DATE: 12/14/90
PROJECT NUMBER: 69028-4
SUBJECT: ADDENDUM TO WORK PLAN

**ADDENDUM TO WORK PLAN
for
ARCO STATION 6113
785 EAST STANLEY BOULEVARD
LIVERMORE, CALIFORNIA**

AGS 69028-4

Subject: Addendum to Work Plan 69028-1W to perform a Subsurface Investigation at the ARCO Station 6113, 785 East Stanley Boulevard, Livermore, California.

PLATE
A

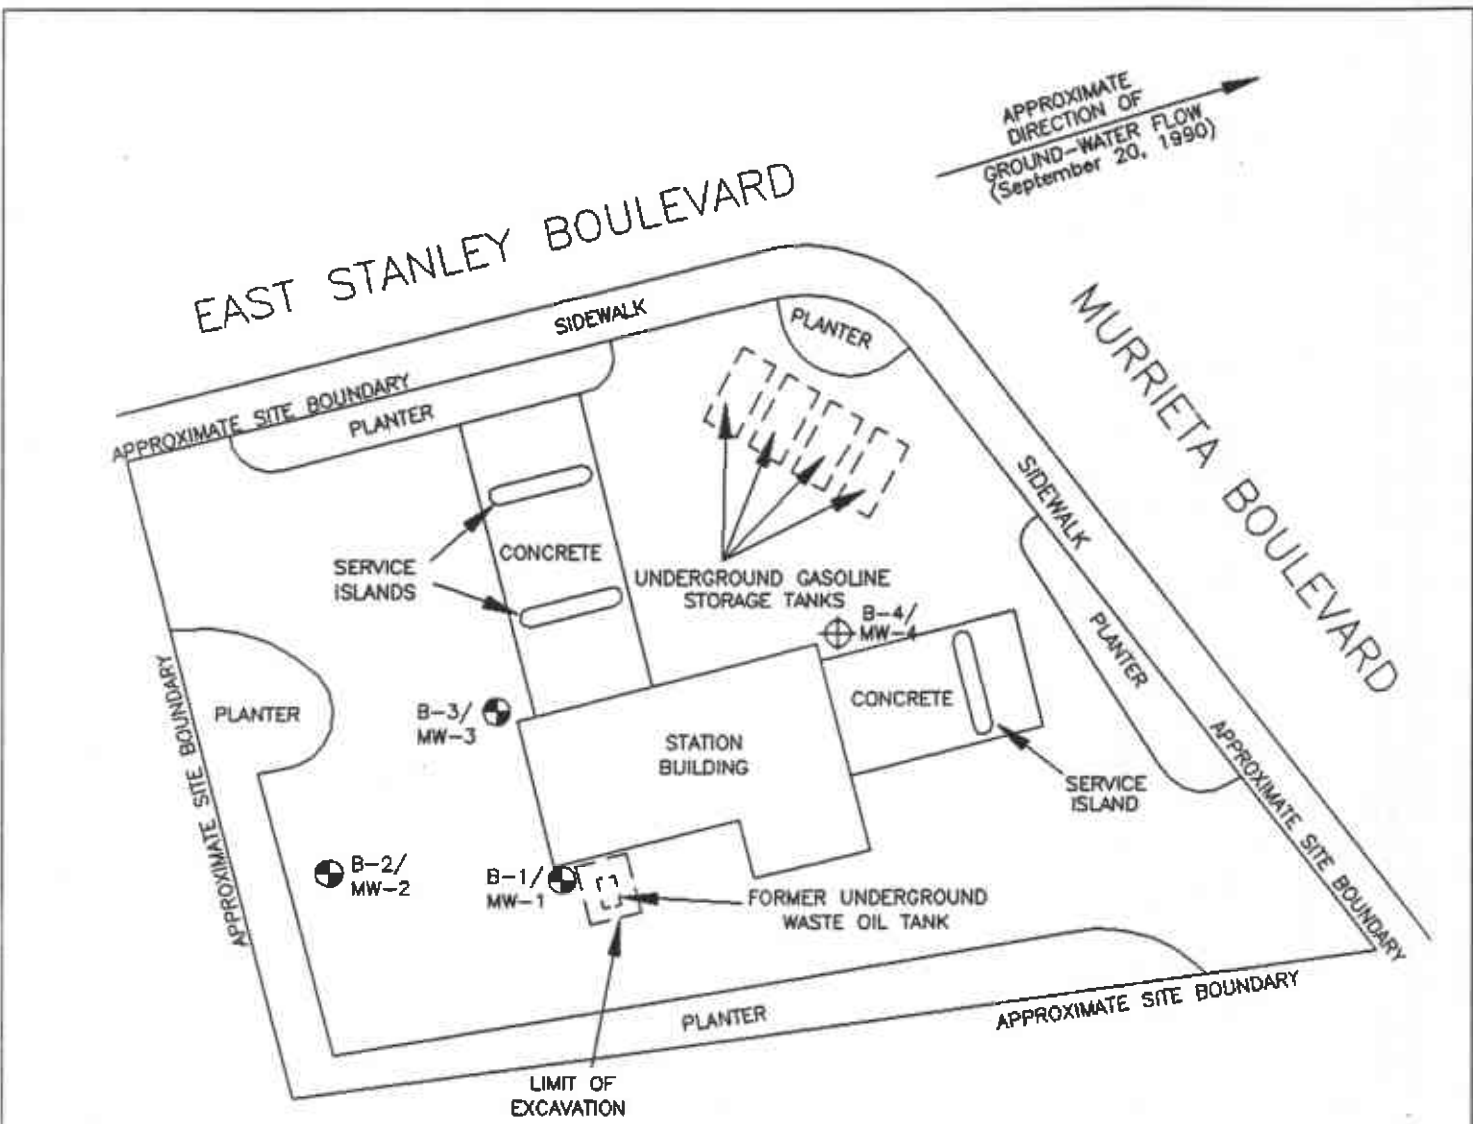
- Task 1 ○ Drill boring B-4 and install well MW-4 in the downgradient direction of the former underground waste oil-storage tank to evaluate the lateral and vertical extent of waste-oil hydrocarbons in the soil and the presence of waste-oil hydrocarbons in the ground water. The proposed location of well MW-4 is shown on Plate A.

PLATE
B

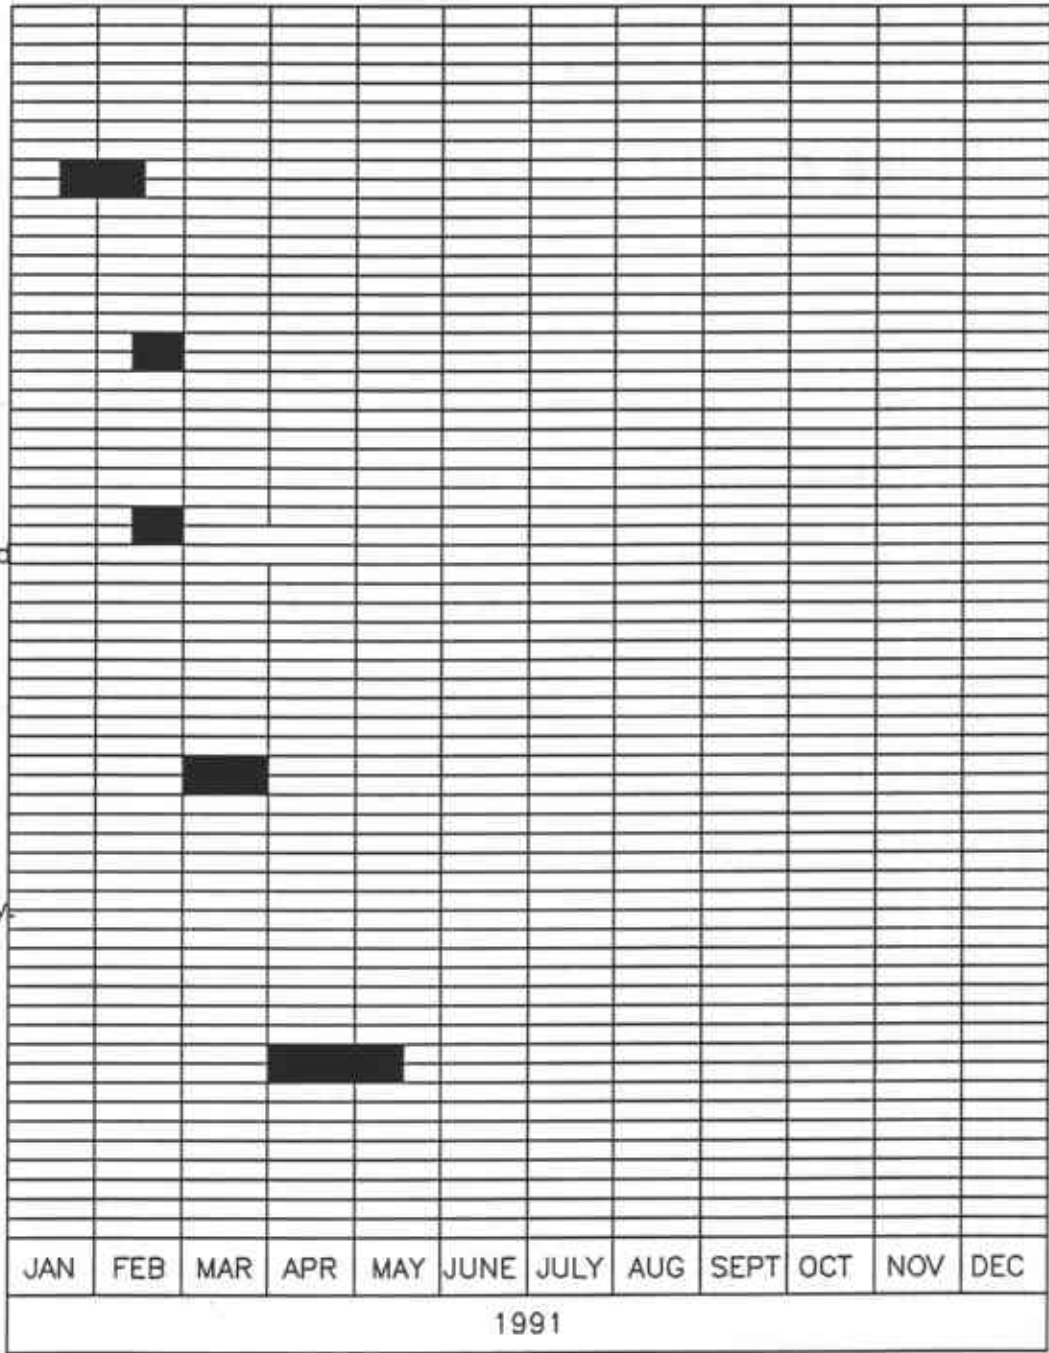
Work proposed in this addendum to Work Plan will be performed in accordance to the protocol in the Work Plan (AGS, July 1989). A Preliminary Time Schedule (Plate B) to perform tasks 1 through 5 has been attached to this addendum. Subsequent addendums to the Work Plan will be prepared and submitted to regulatory agencies as necessary to
